CITY PLANNING COMMISSION

- APPLICATION:
1. Negative Declaration
 2. Rezone 27± vacant acres from Garden Apartment-Review (R-2A-R) to Garden Apartment (R-2B)
 3. Special Permit to modify P82-228 in order to develop 520 apartment units

APPLC. NO. P83-083

MEETING DATE April 14, 1983

SITE PLAN

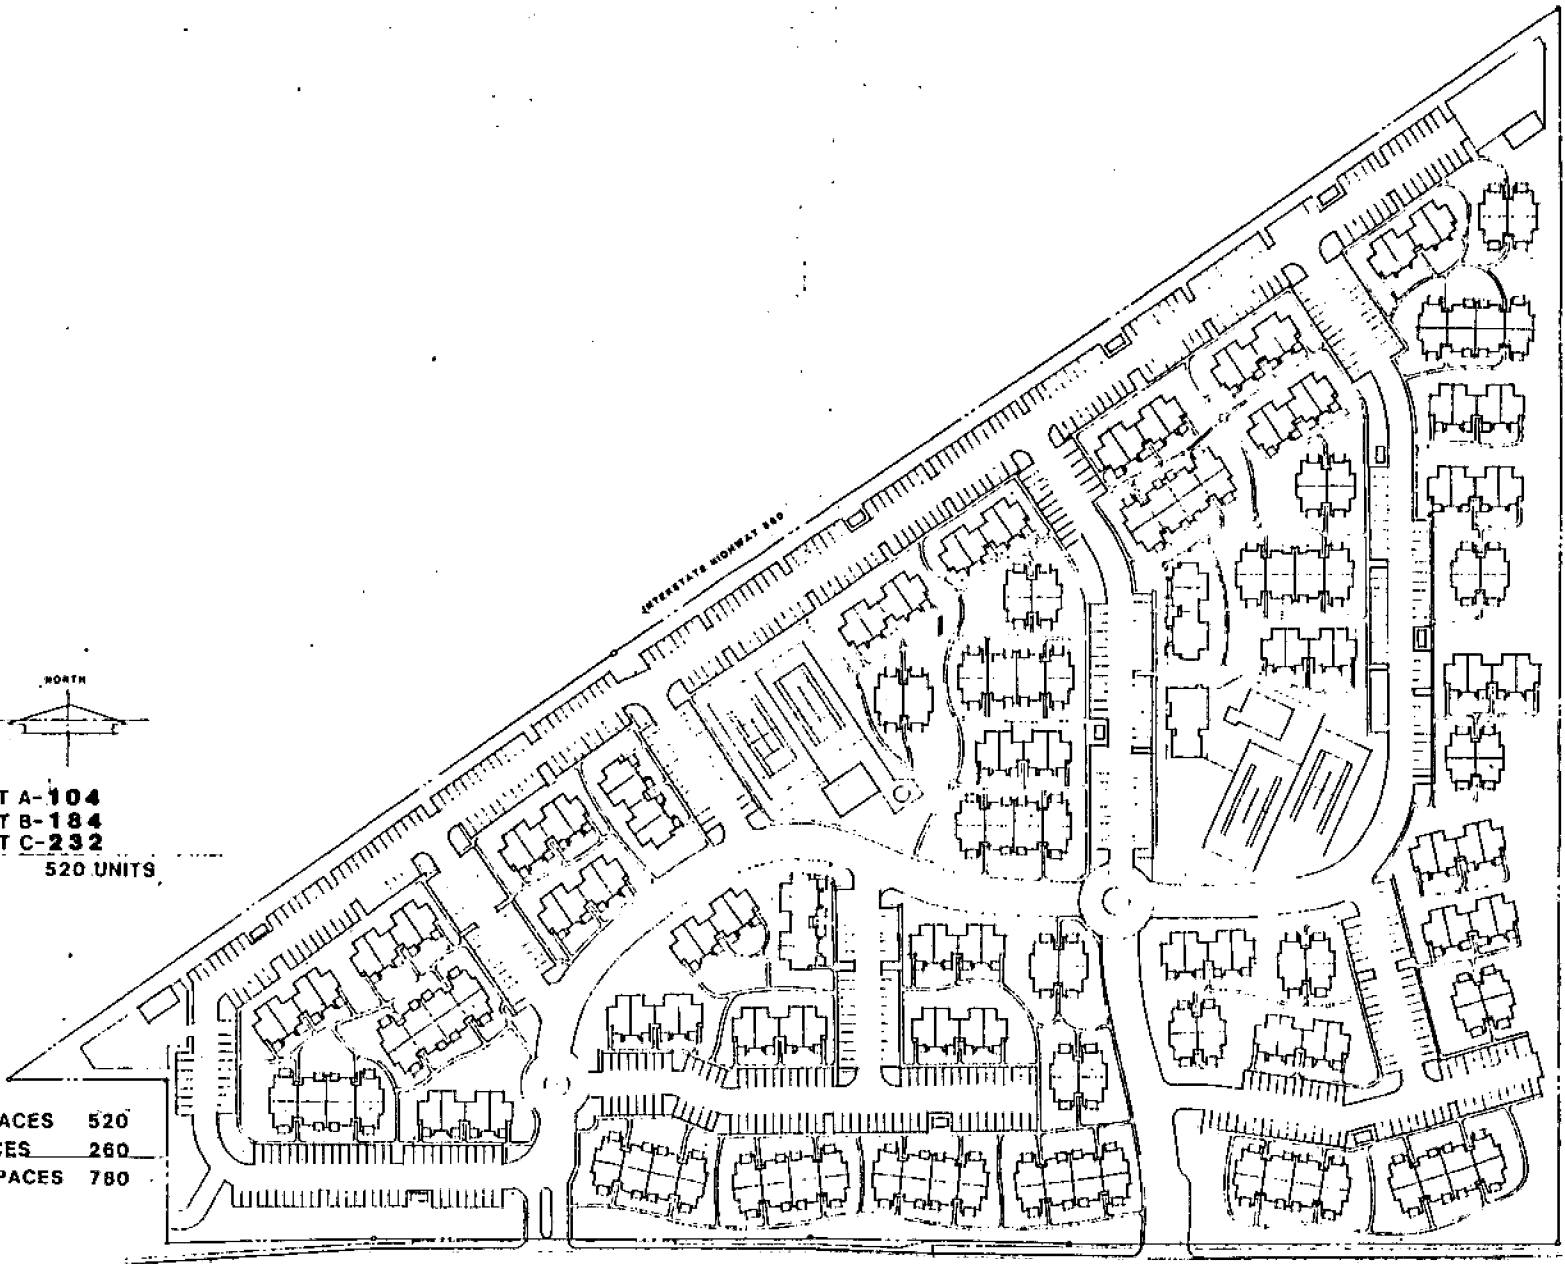
8. The revised site plan does not show the location of trash enclosures. Staff requests that the applicant submit a detailed site plan subject to staff review and approval indicating location and design of trash enclosures prior to the issuance of building permits. The design of trash enclosures shall adhere to the trash enclosure criteria in exhibit A.

- e. The two pools indicated on the site plan shall be heated by solar energy only.
- f. The applicant shall submit a detailed landscaping and irrigation plan for review and approval of the planning staff prior to the issuance of a building permit. The plan shall include elements that are indicated in exhibit A design criteria.

- j. The applicant shall redesign the private loop street to a width of 36 feet curb to curb.
- k. The applicant shall submit detailed plans of trash enclosures and bicycle storage facilities for review and approval of the planning staff prior to issuance of a building permit.

FRONT ELEVATION

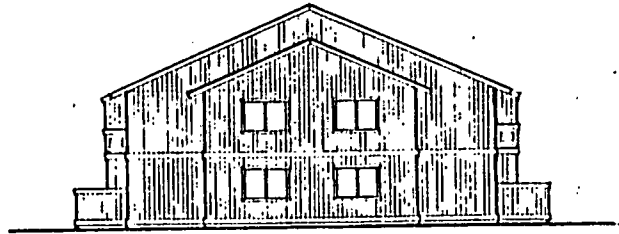
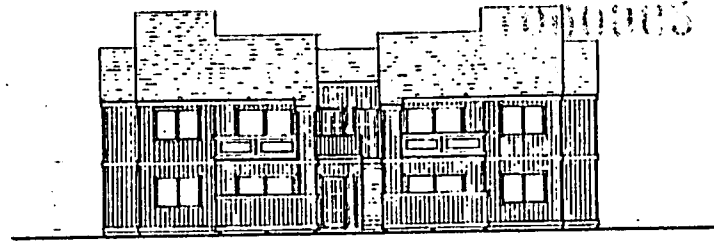
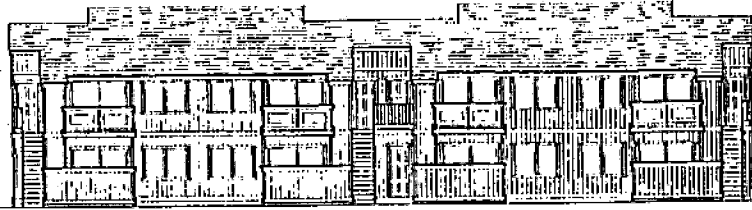
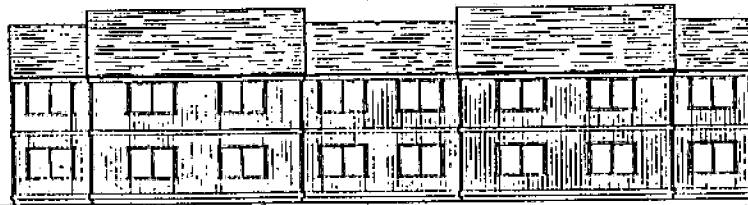
4. Staff finds the proposed apartment buildings deficient in design relief. The utilization of only vertical wood siding is too limiting given the large number of units and buildings.

Staff recommends that the applicant incorporate additional design modification on the exterior elevations. These modifications should include the utilization of stucco or similar materials as well as additional windows or alternative treatments. The representative of Pacific General has indicated a willingness to make these modifications.

- b. Revised elevations shall be submitted to staff for review and approval prior to issuance of building permits. These revised elevations shall incorporate the use of stucco or a similar type material on the exterior of at least 25% of the units or building structures. In addition, other modifications may be required so as to visually enhance the exterior elevations.
